Double Bay Residents' Association

4th December 2022

DA 453/2022/1 55 Bay Street, Double Bay

(Woollahra Development Control Plan, Chapter D5 Double Bay Centre, D5.5.8 Control drawing 4, 2015)

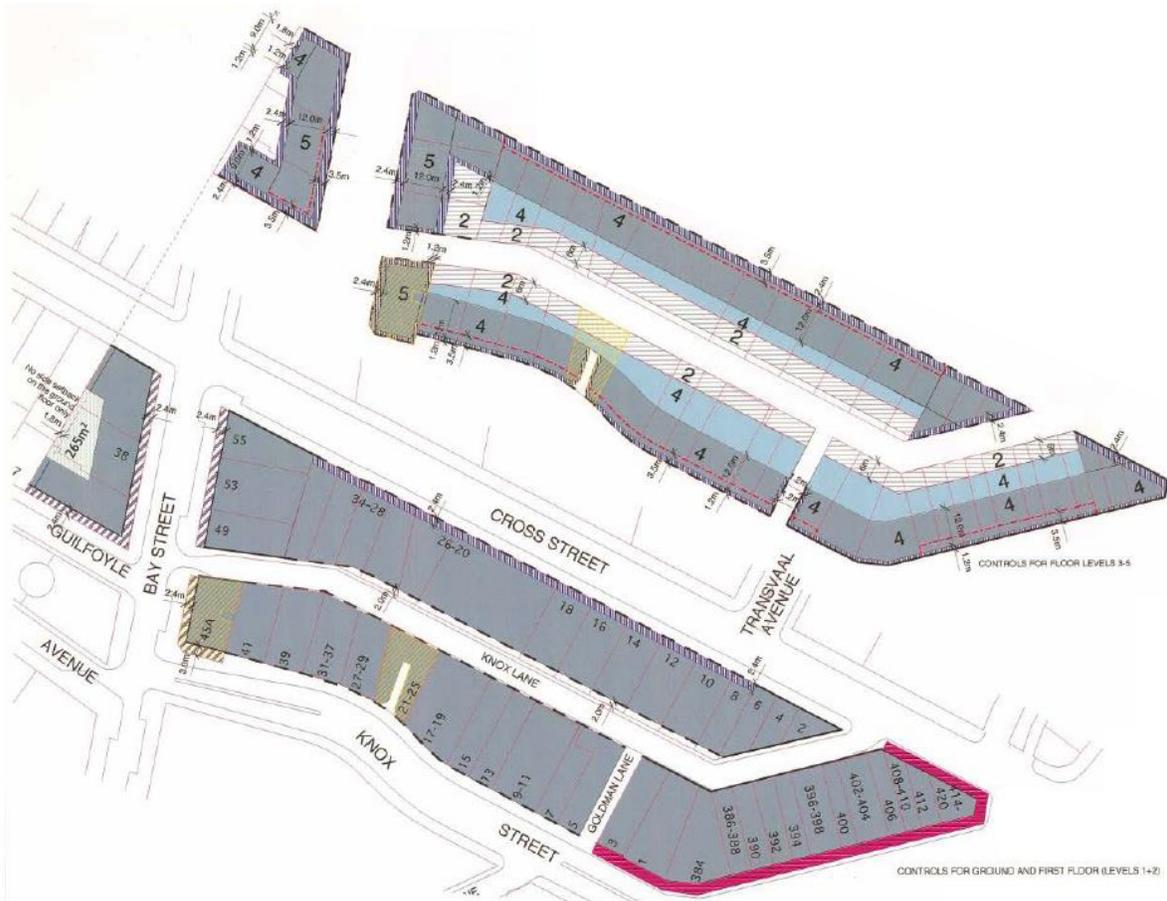
The building envelope is to be restricted to 5 storeys (see Control drawing 4) defined as a maximum overall height of 18.1m. Along both Bay Street and Cross Street the Applicant has proposed a street wall of 18.1m (see drawing DA301 and DA302). However, under the DCP the maximum street wall height along the southern side of Cross St is 3 storeys or 11.5m (see DCP - D5.4.7 Cross St accompanying diagram). The section also specifically states for development on the south side of Cross Street “Set back level 4 development from the street boundary” with a setback of 2.4m for storeys 3-5. Along Bay Street there is a 2.4m setback along Bay Street for storeys 1-5.

In relation to “a) Lot amalgamations” there is no question that this site is in proximity to Guilfoyle Park. It was obviously intended by the draftsman of the LEP’s Height map and this part of the DCP that this site would be amalgamated with the adjoining 51-53 Bay Street which shares the higher 18.1m height limit afforded corner sites. With a site area of 320.5m², less than half of a home site, the property is unsuited for this scale of development. The site has a strange configuration with a 30.015m long frontage along Cross Street and a short 13.46m frontage upon Bay Street, with a splay of 2.178m linking these frontages. The south boundary is 29.97m (adjoining 53 Bay Street) and the east is only 5.965m adjoining 28-34 Cross St. For such a small and difficult shaped site an 18.1m height as approved was pushing it to the limits already.

A 2.5m setback is required along Bay St, east side, on ground to level 4 as indicated in D5.4.5 and D5.5.8 Control drawing 4. The proposed development is grossly non-compliant with this, having a setback of 0m on the ground floor, 0m-0.4m on the level 1 and a setback ranging 0.4 to 0.7m for levels 2-4.

Similarly, a 2.5m setback is required along Cross St on levels 2 to level 4 as indicated in D5.4.7 and D5.5.8 Control drawing 4. The proposed development again is seriously non-compliant with a setback of 0.4 to 0.7m for levels 2-4 along Cross Street. The top floor should simply not be there.

Building articulation contributes to the character of the street and contributes to the street façade. It helps establish passive surveillance and promote open space. D5.5.8 Control drawing 4 shows the site specific articulation area, a 2.4m articulation zone is required to both Bay Street (ground-level 4) and Cross Street (level 1-4). Control 1 of 5.6.3.3 Building articulation determines the percentages of internal and external space to be incorporated into the building design. These are summarised below:
